ENCLOSURE 2

M210133

Revised Pages

Licensing Topical Report  
NEDO-33914, Revision 0,  
BWRX-300 Advanced Civil Construction and Design Approach

**Figure 4-2: Interface Rheologic Modeling**

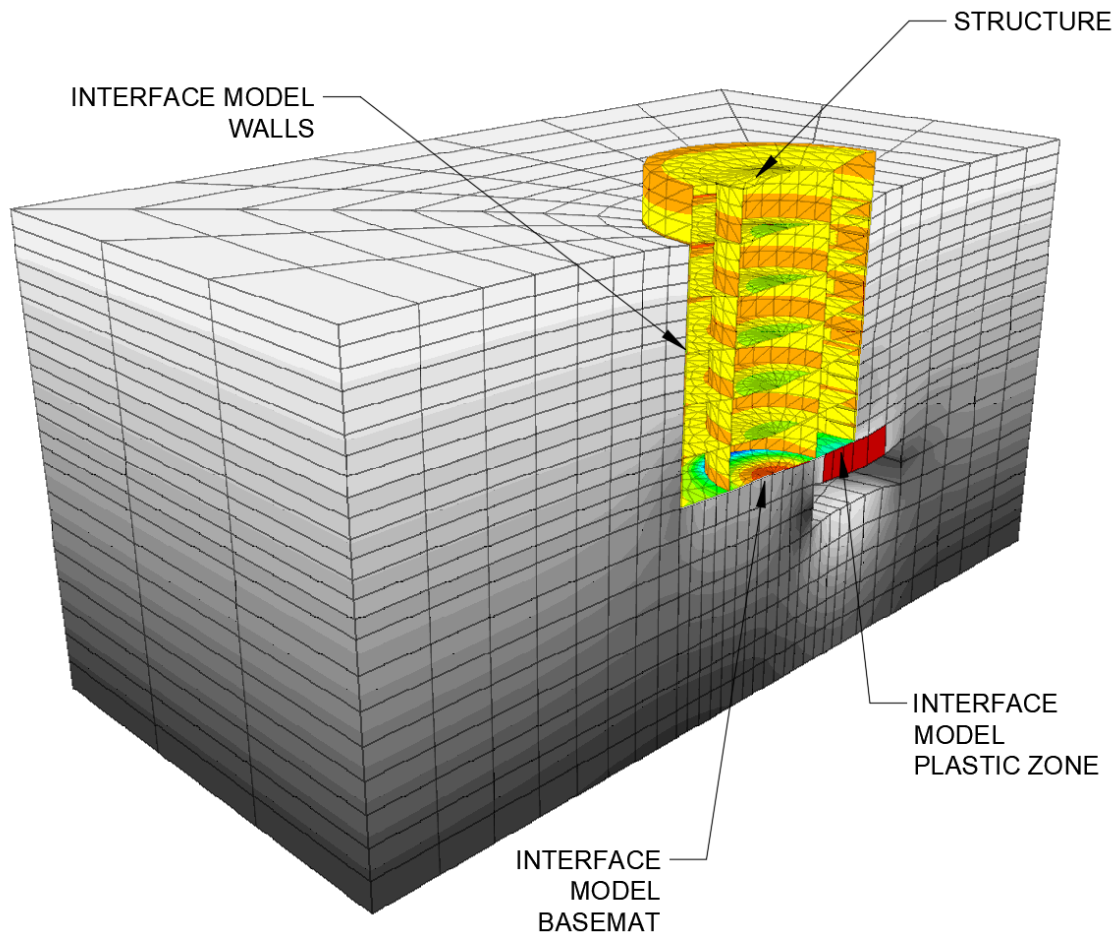
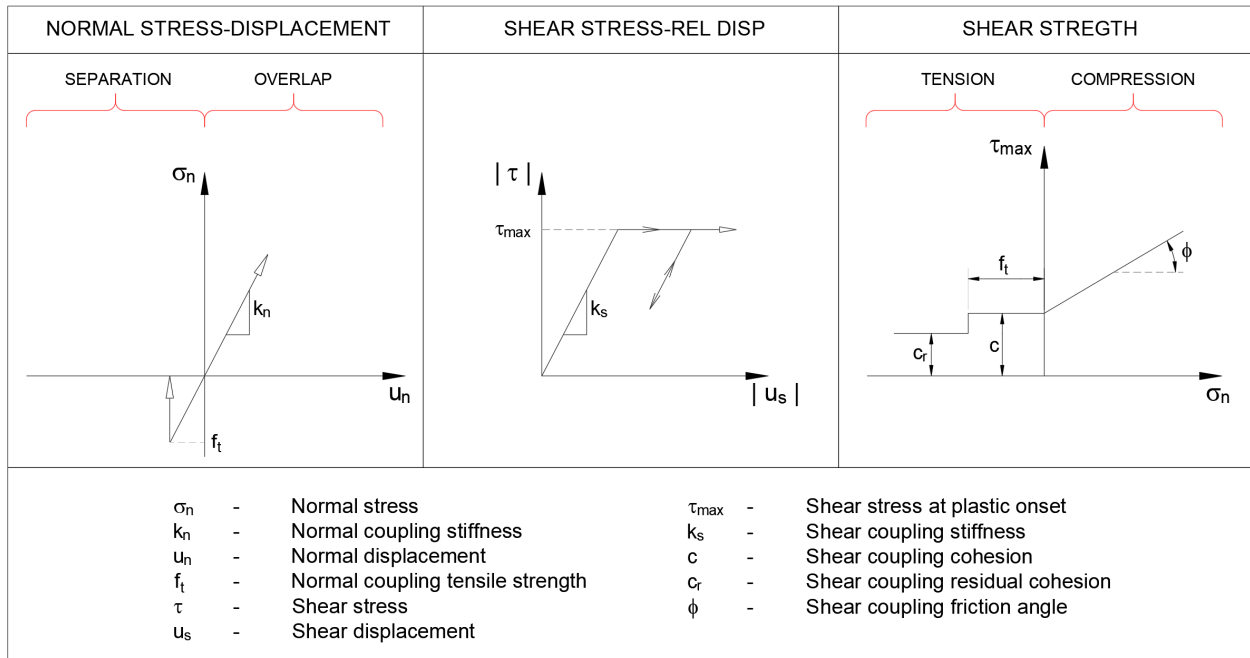
The parameters of the slipping spring can be taken from the material set of the adjacent soil/rock elements [or strength tests on natural and artificial discontinuities from the site investigation, laboratory testing program and characterization programs as described in Sections 3.1.2 and 3.1.3. The development of the interface parameters should be consistent with the limitations and modeling guidance of the software and interface model used for the nonlinear FIA.](#) A strength
